PCD Project Manager_2026-06-10_004 - Site Development Plan.pdf Markup Summary

Subject: Text Box
Page Label: [57] S-1 Site Development Plan
Author: dsdparsons

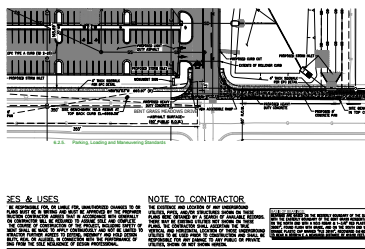
Subject: Text Box
Page Label: [57] S-1 Site Development Plan
Author: dsdparsons

Educational Institutions
Elementary or Junior High2 spaces per classroom
Senior High1 space per 4 students PLUS ADA parking per Code

RESPONSE: SCHOOL IS A K-8 ONLY.

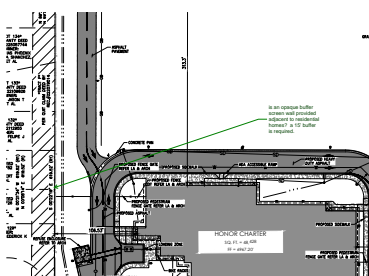
title block

RESPONSE: ADDED

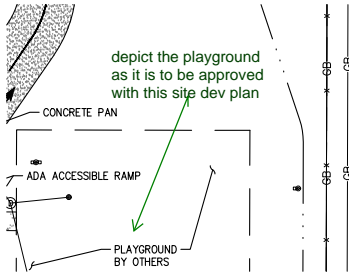
what is this area? what is surface

RESPONSE: SODDED ATHLETIC FIELD

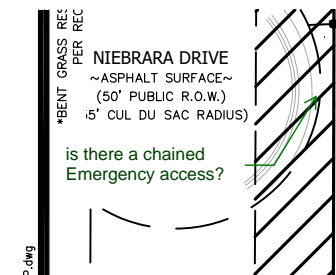
Please add site development plan checklist add missing items

RESPONSE: NOTED
